New brake disc with ECO Plus 3 series launch

We will start the series launch of the 9t - ECO Plus 3 bearing technology, with the introduction of the offset 120 version and disc brake (offset 120 Wheel-End) on the 15th of May 2015.

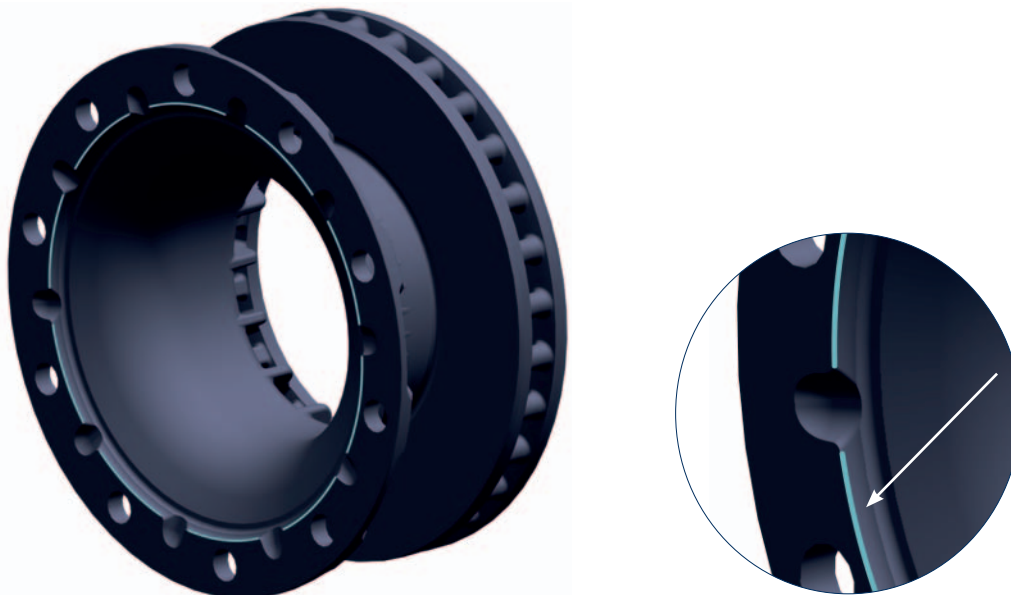
With the introduction of ECO Plus 3 the geometry of the disc changes.

In unfavorable tolerance positions, it may happen that the old brake disc does not fit optimal to the new ECO Plus 3 hub with offset 120.

Therefore, in the area of connection to the hub, the brake disc is provided with an additional chamfer.

The new brake discs are backward compatible and can also be mounted on the previous axle configurations.

The old brake discs should not be mounted on the new ECO Plus 3 hub.
